# PLATTE SELF STORAGE

## GRADING AND EROSION CONTROL PLAN

### OVERVIEW SHEET

AUGUST 2024

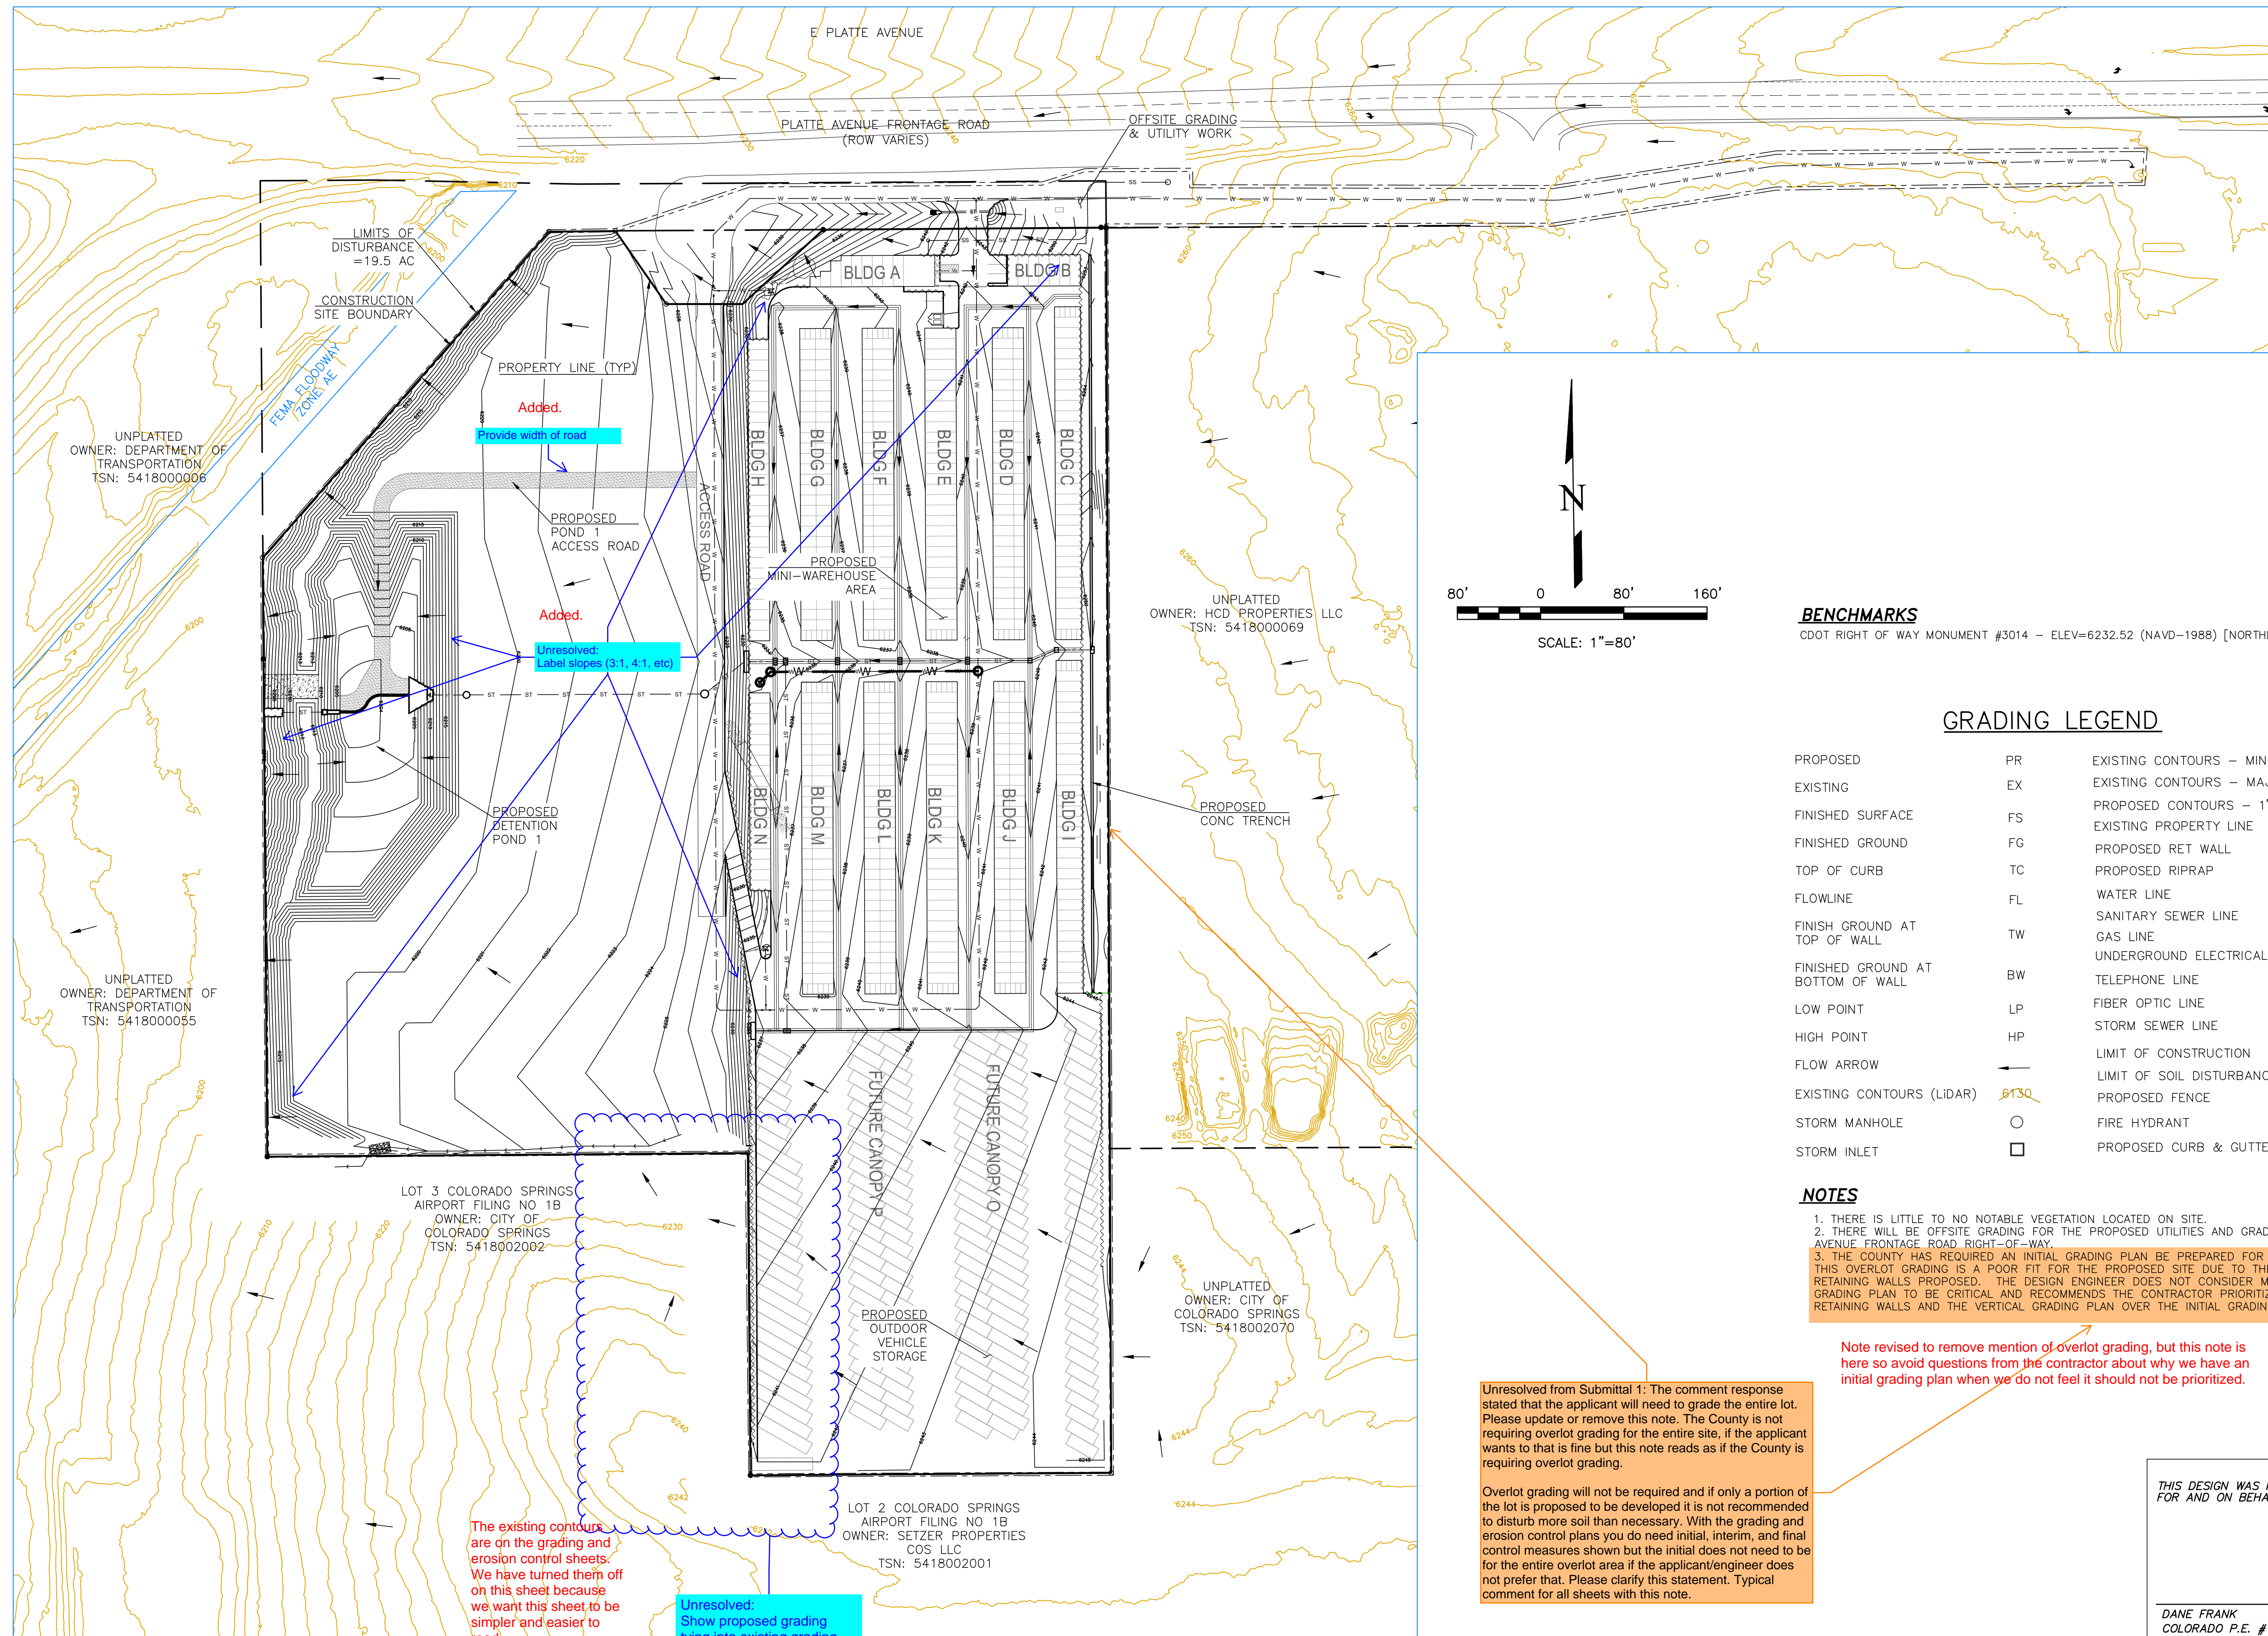
Unresolved from Submittal 1: The comment response stated that the applicant will need to grade the entire lot. Please update or remove this note. The County is not requiring overlot grading for the entire site, if the applicant wants to that is fine but this note reads as if the County is requiring overlot grading.

Overlot grading will not be required and if only a portion of the lot is proposed to be developed it is not recommended to disturb more soil than necessary. With the grading and erosion control plans you do need initial, interim, and final control measures shown but the initial does not need to be for the entire overlot area if the applicant/engineer does not prefer that. Please clarify this statement. Typical comment for all sheets with this note.

Unresolved: Show proposed grading tying into existing grading

Note revised to remove mention of overlot grading, but this note is here so avoid questions from the contractor about why we have an initial grading plan when we do not feel it should not be prioritized.

The existing contours are on the grading and erosion control sheets. We have turned them off on this sheet because we want this sheet to be simpler and easier to read.

**PLATTE SELF STORAGE**  
GRADING AND EROSION CONTROL PLAN  
INITIAL - NORTH SIDE

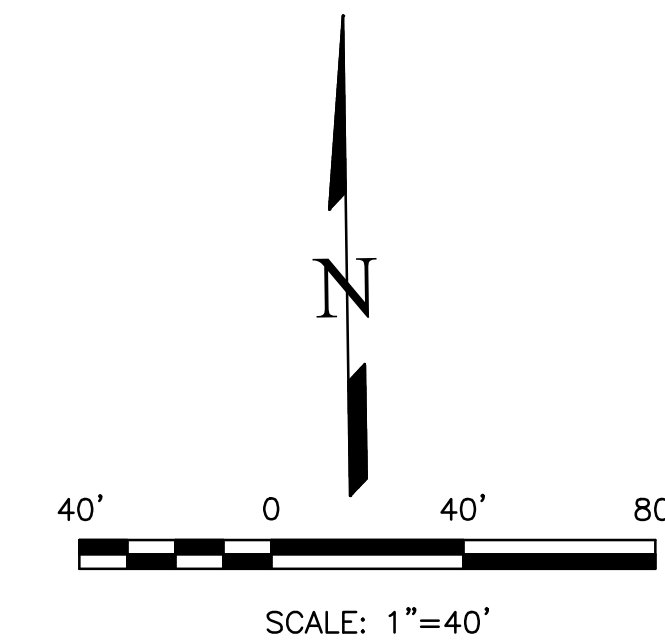
Please include full limits of construction within the view, it appears to extend further to the east.

NO GRADING IS BEING DONE IN THIS AREA THAT ISN'T SHOWN ON THE DETAIL SHEETS. THIS AREA IS SHOWN ON THE OVERVIEW PLAN, BUT IS NOT SHOWN ON THESE DETAIL SHEETS BECAUSE IT IS ONLY UTILITY WORK.

**PLATTE SELF STORAGE**  
GRADING AND EROSION CONTROL PLAN  
INTERIM EROSION CONTROL PLAN - NORTH SIDE

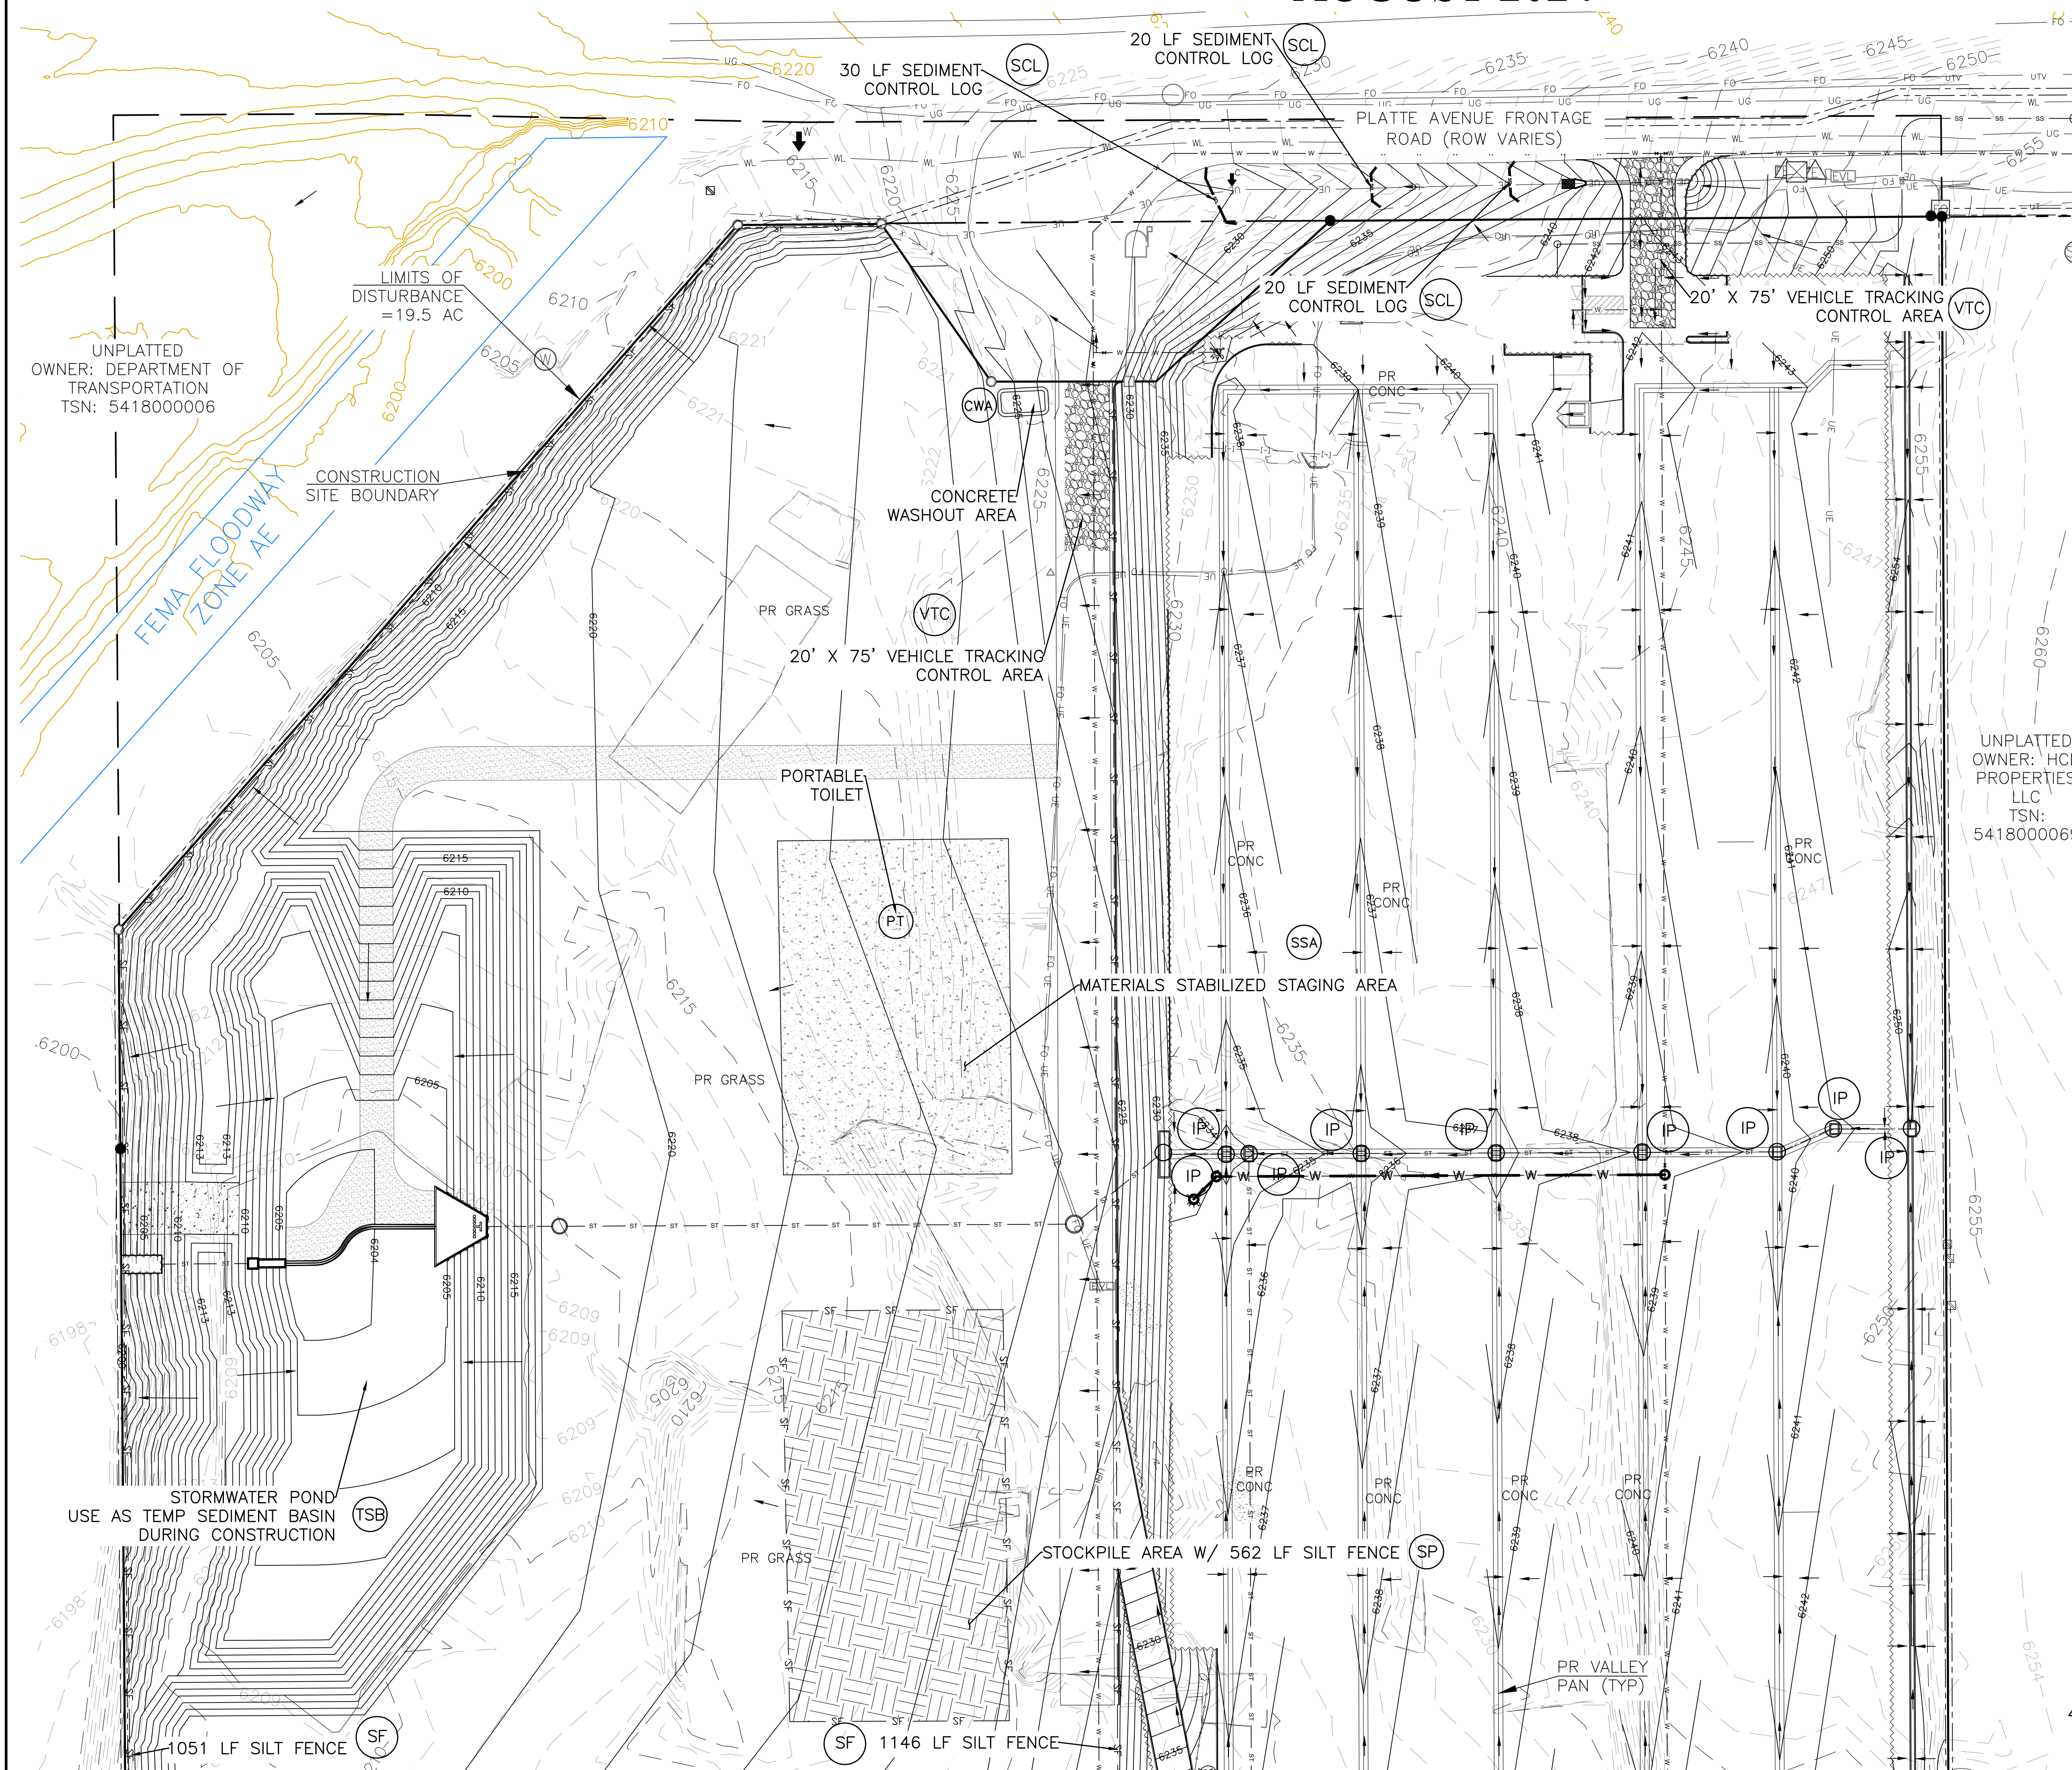
**Unresolved:**  
Show cut/fill limits

**THE CUT/FILL LIMITS ARE SHOWN ON THE FINAL VERTICAL EROSION CONTROL PLAN SHEETS.**
